**ADDENDUM NO. 01  
October 24, 2022**

**BALES INTERMEDIATE AND WESTWOOD ELEMENTARY RENOVATIONS ISSUE FOR  
PROPOSAL  
FOR FRIENDSWOOD I.S.D.**

Prepared by: PBK  
11 Greenway Plaza, 22<sup>nd</sup> Floor  
Houston, TX 77046-1104  
PBK Project No: 220083

M-101A

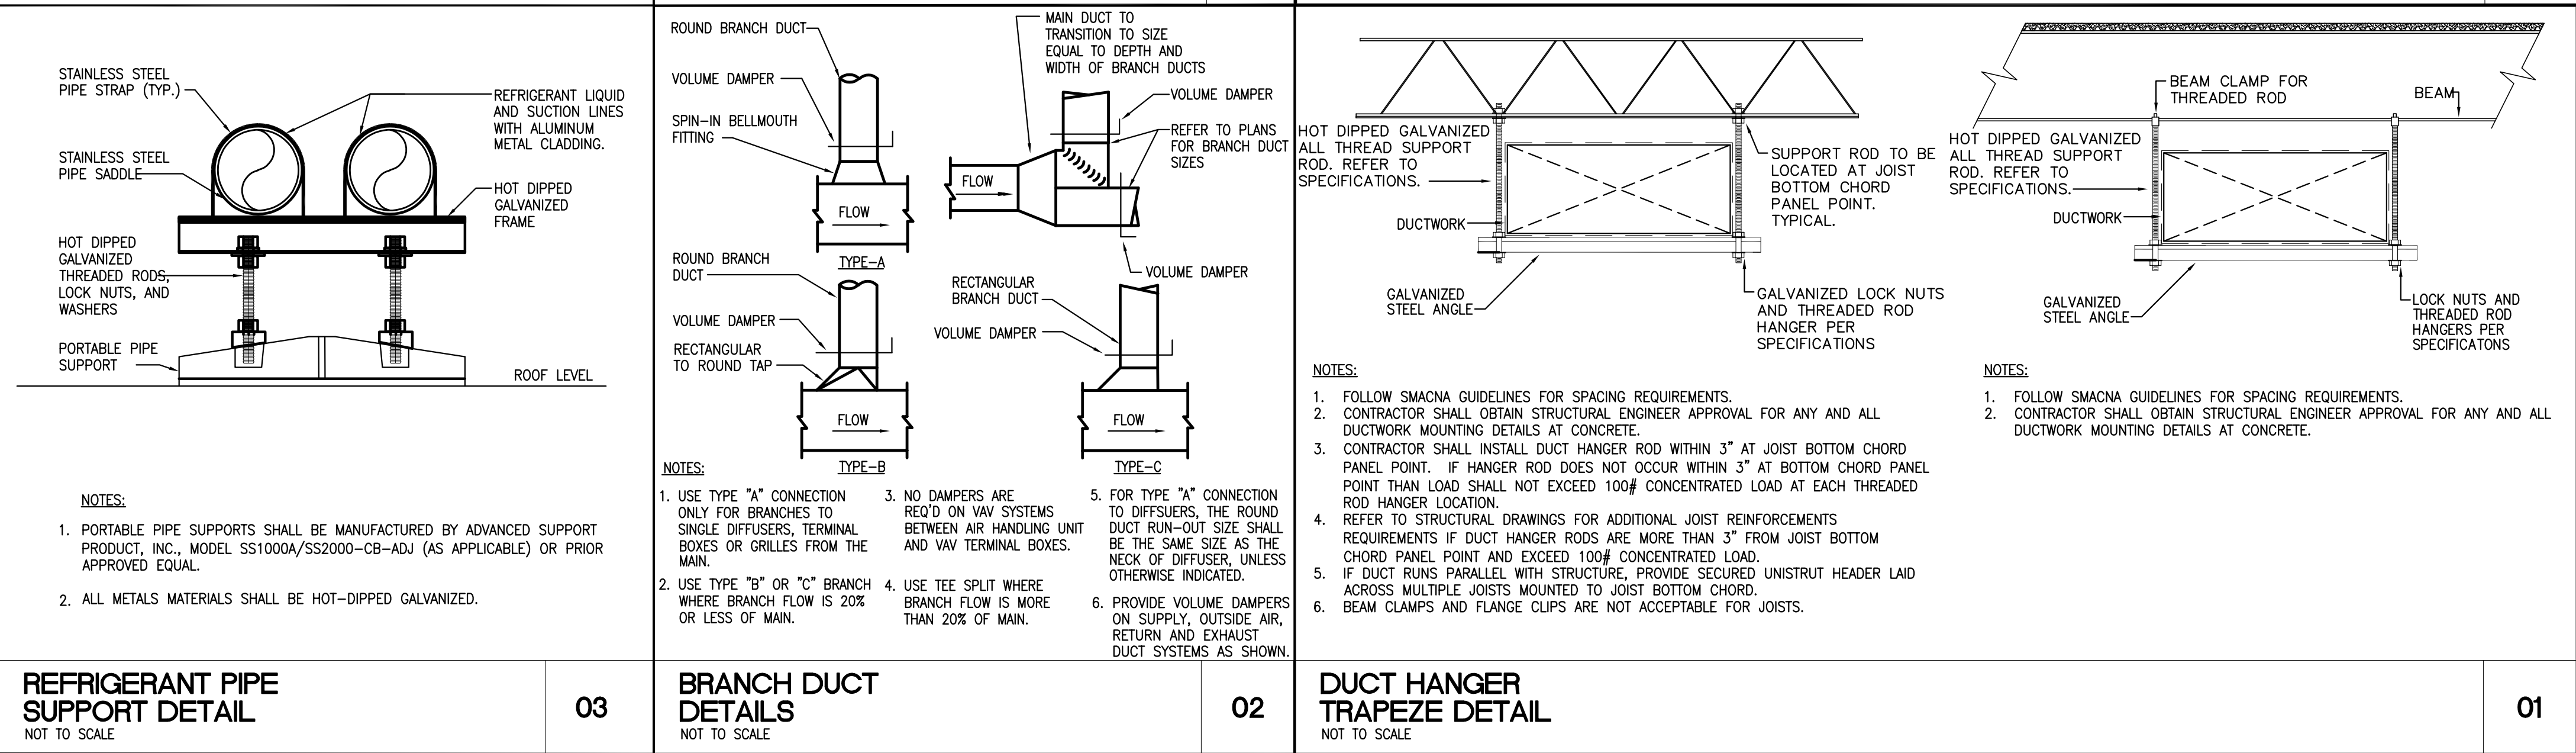
- Item No. 01     **SHEET M-101A – 1<sup>ST</sup> LEVEL - MECHANICAL PLAN – AREA A (Bales)**
1. Added keyed note 4: "Provide new motorized damper in existing duct work. Interlock with associated exhaust fan."

2. Added motorized damper symbol and keyed note 4 to EF-14 & EF-1 in Mechanical Room UE1 and the Boy's Restroom next to Storage Room B8 respectively.

EP-101B

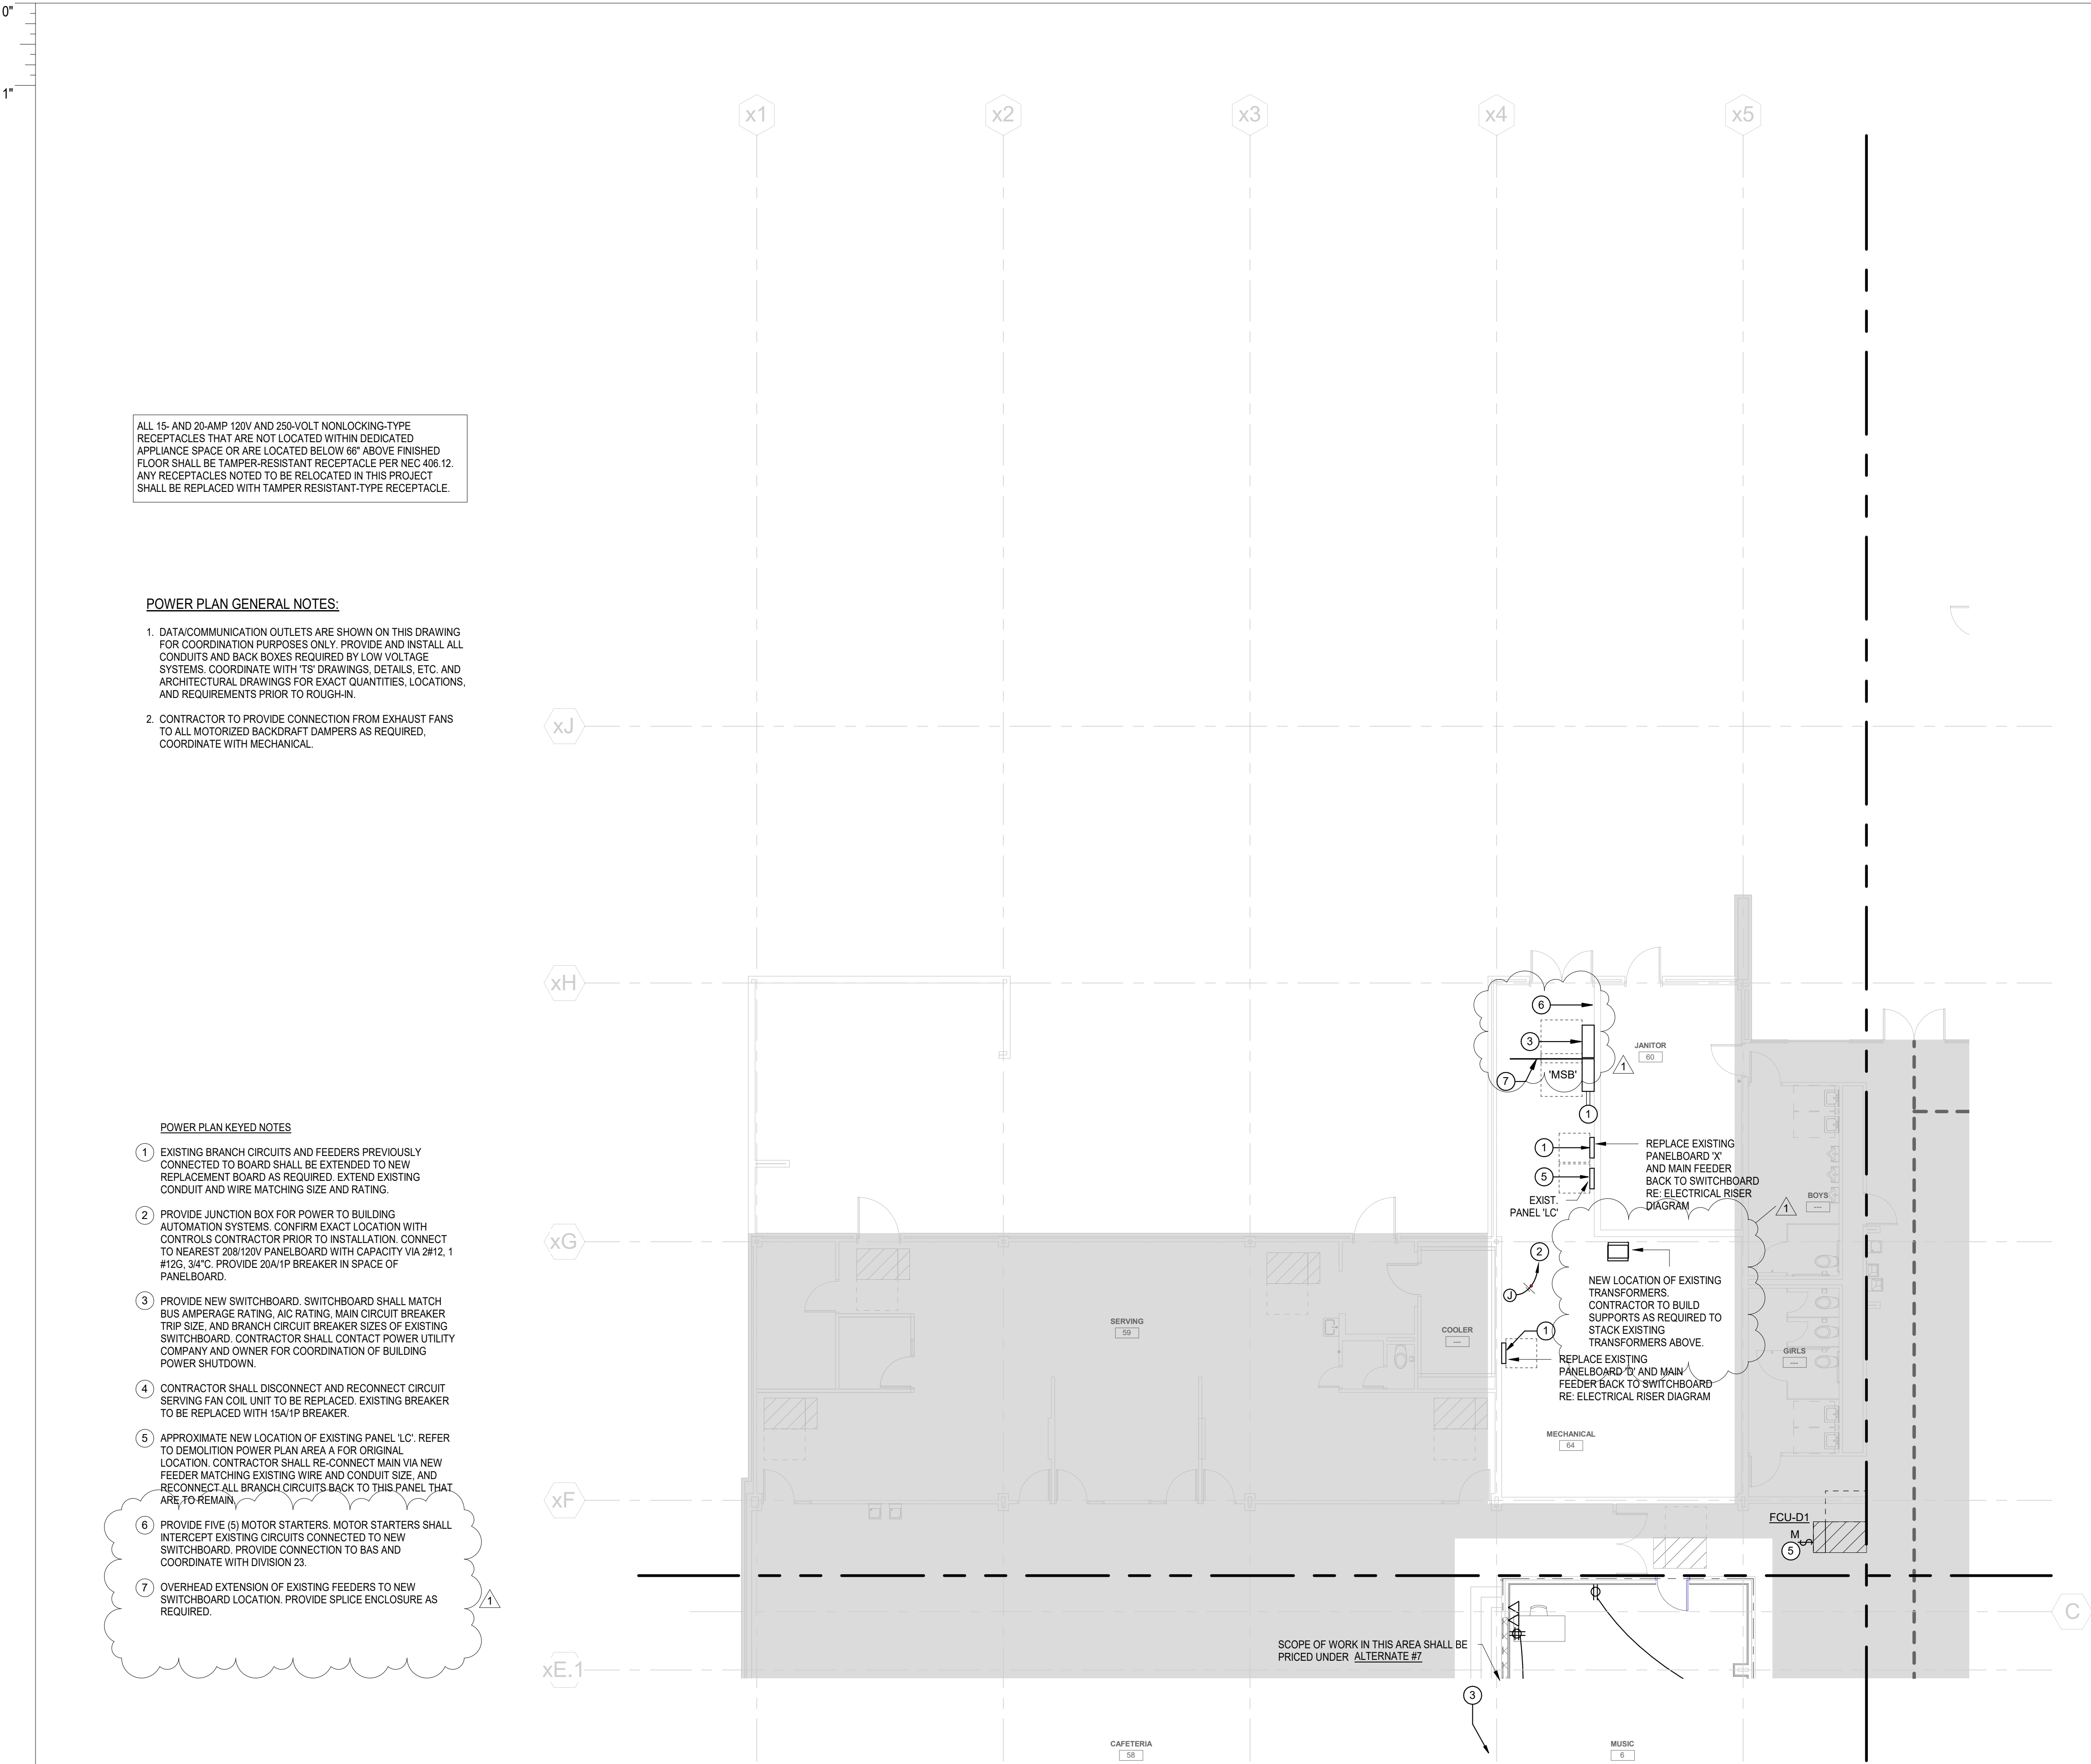
- Item No 05      **Sheet – EP-101B – 1<sup>ST</sup> FLOOR POWER PLAN – AREA B (Bales)**  
1. Delete circuit to BAS panel in room Mechanical #D9.
- Item No 06      **Sheet – EP-101D – 1<sup>ST</sup> FLOOR POWER PLAN – AREA D (Bales)**
